# Product / Process Change Notification

N° **2015/03**

*Changing of packing and packing unit of V1-A-Pack*

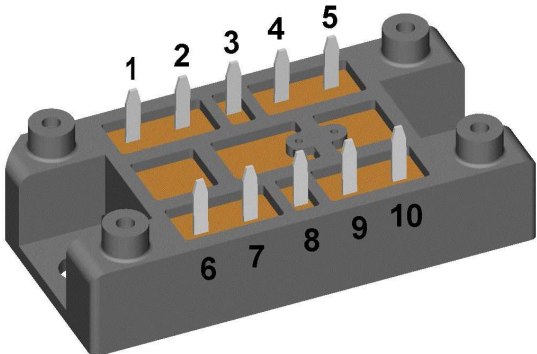
<b>DESCRIPTION OF CHANGE:</b>	<b><u>OLD</u></b>	<b><u>NEW</u></b>
■ <i>Packing</i>	<i>Cardboard box</i>	<i>Blister</i>
■ <i>Packing unit</i>	<i>10</i>	<i>24</i>
